Review of Vermont Yankee Thermal Discharge Modeling

February 6, 2012

This report provides a review of a report entitled, *Hydrothermal Modeling of the Cooling Water Discharge from the Vermont Yankee Power Plant to the Connecticut River* by Applied Science Associates (ASA 2004). The 2004 hydrothermal modeling report was submitted in support of a 316(a) demonstration for the Vermont Yankee Power Plant. The thermal impact analysis provided in the 2004 demonstration was framed as an incremental update of two previous 316 demonstrations, conducted in 1978 and 1990. As a result, it was necessary to review and briefly summarize the thermal studies associated with the 1978 and 1990 demonstrations in this report.

Figure 3-1. Example of model calibration figures from 2004 report (ASA 2004).

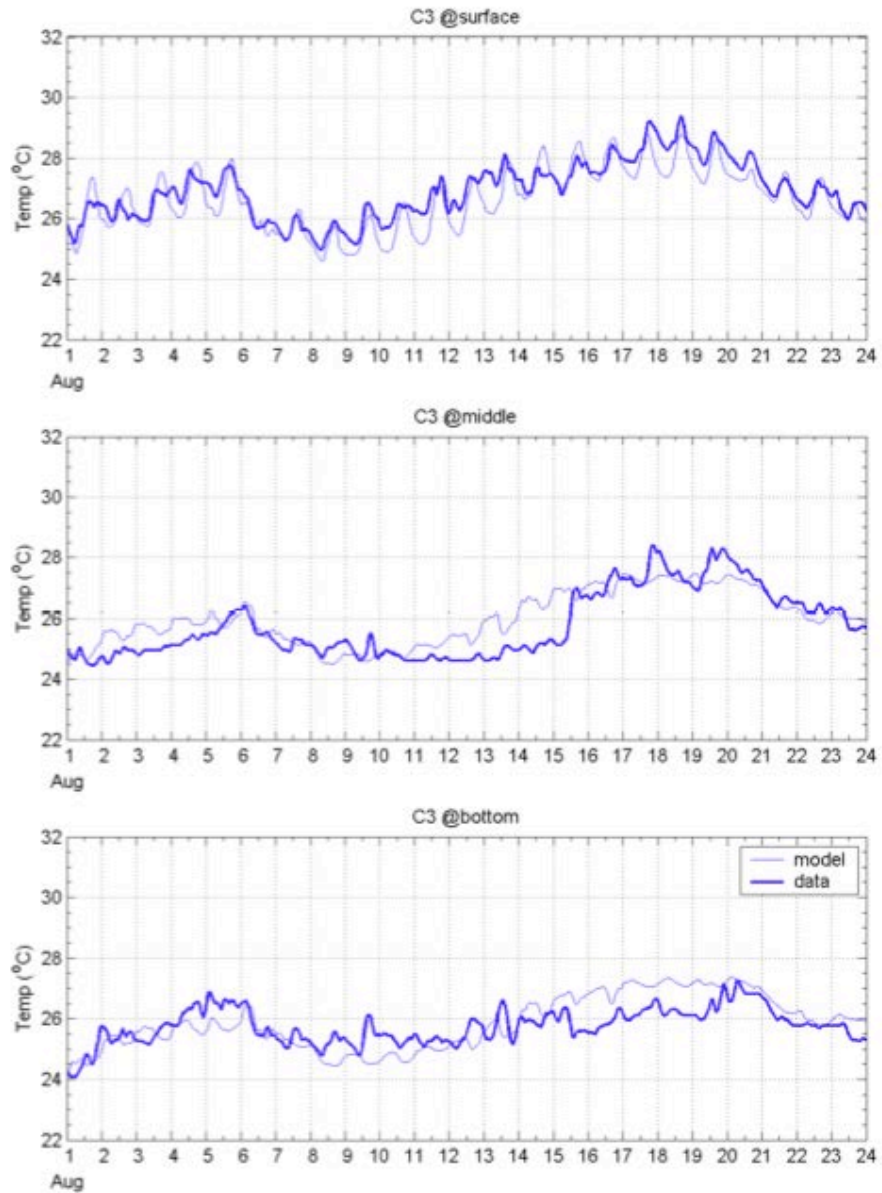
ASA (2004) indicates the model was calibrated to dynamic river conditions over a 24-day period, August 1-24, 2002, “when air temperature was in general warmer than any other month and river temperatures were warmest.” (ASA 2004, p. 32). The model was confirmed during a 15-day period from June 25 to July 9. Time-series plots and statistical summaries of predicted vs. measured temperature data during the two calibration periods are provided in the report. An example plot is included here as Figure 3-1. The report does not indicate the corresponding Vermont Yankee discharge flow rates and temperatures or river flow rates that occurred during the calibration and confirmation time periods (e.g., in a format similar to Figure 2-3 from the 1978 study).

Figure 3-2. Predicted surface temperature from a 2004 model scenario (ASA 2004).

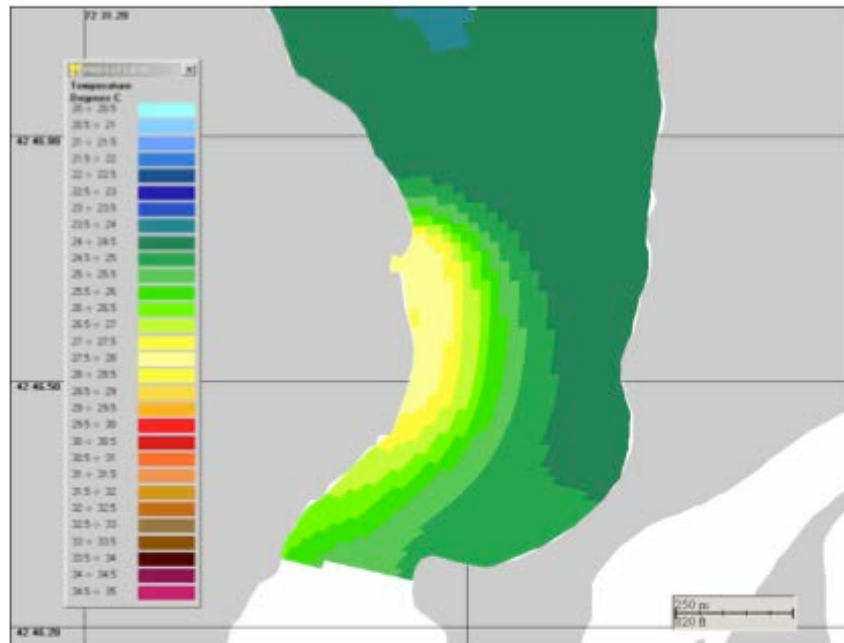
The 2004 hydrothermal model output requirements were not explicitly stated in the ASA (2004) report and the model report provides limited output. A narrative description of model results is included in the report and is framed as predicted temperature change associated with the proposed discharge temperature increase (as described in a. above). A set of three plan-view maps is provided for only one of the ten model scenarios. The three maps represent predicted temperatures at surface, mid-depth, and near-bottom in Vernon Pool. The surface temperature map is reproduced here as Figure 3-2. Maps of the other nine model scenarios results were not included in ASA’s report. Lastly, predictions are summarized through temperature-exceedance plots covering the ten simulation scenarios. The exceedance plots show:

The ASA report did not provide results consistent with those specified in the EPA 316(a) guidance (EPA 1977). Specifically, the ASA report did not provide maps of the thermal discharge plume out to the 1°C isotherm under a variety of conditions. The ASA report also did not provide the areal extent of the thermal plume and the associated conditions (i.e., Vermont Yankee operations, ambient river conditions, and Vernon Dam operations) under a variety of conditions. The ASA report failed to provide a sufficient temperature characterization of the Connecticut River study area.
